PCN25-2–
KMT2 Series Teflon Film Change

C&K

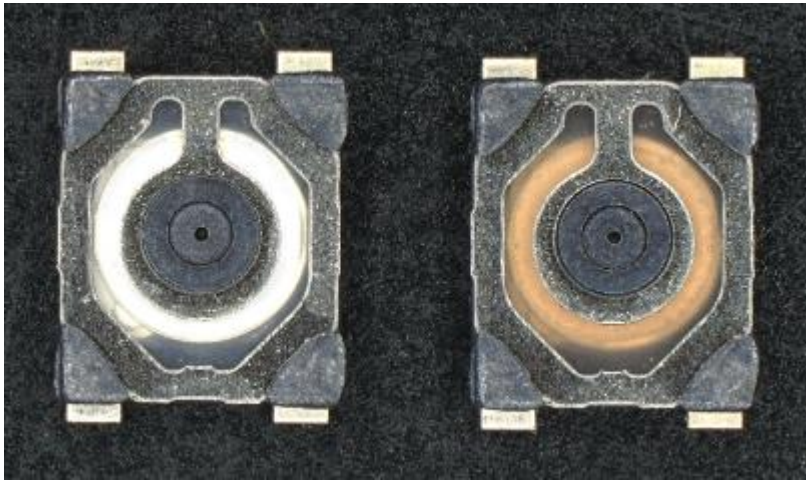
Visual change:

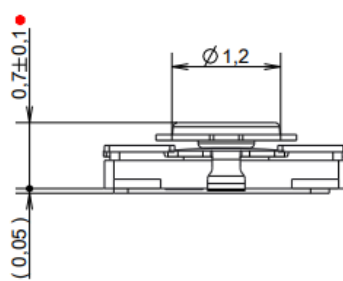
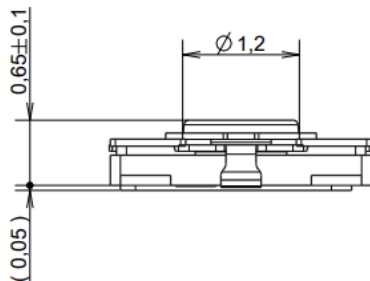
The product height is adjusted as follows, from 0.65mm +/-0.1 to 0.70mm +/-0.1:

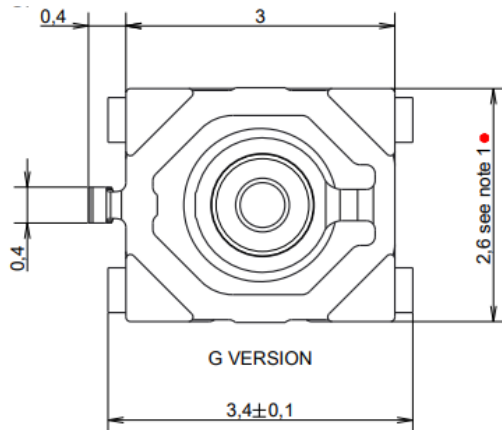
The following note has been added to the drawing of this switch related to the product width:
“Note 1: This dimension can locally reach 2.8mm in the heat stacked areas.”

● NOTE : - 1 - This dimension can locally reach 2,8mm in the heat stacked areas
